DVN: Russell 8 Fed 1 API #30-015-31392 Sec 8-T20S-R29E Eddy County, NM

Purpose: Abandon Morrow perfs and recomplete up hole to Atoka

Russell 8 Federal 1 30-015-31392 Devon Energy Production Co., LP August 08, 2014 Conditions of Approval

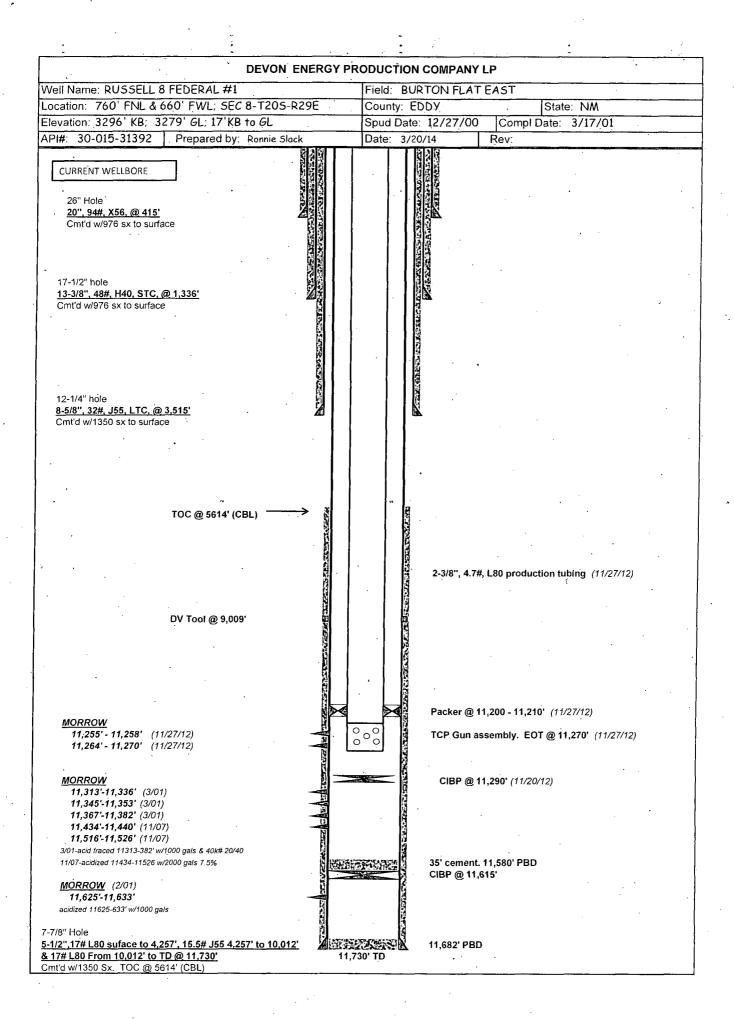
- 1. Operator shall place CIBP at 11,200' and place a minimum of 25 sx class H cement plug on top. Tag required at a minimum depth of 11,000'.
- 2. Must conduct a casing integrity test before perforating and fracturing. Submit results to BLM. The CIT is to be performed on the production casing to max treating pressure. Notify BLM if test fails.
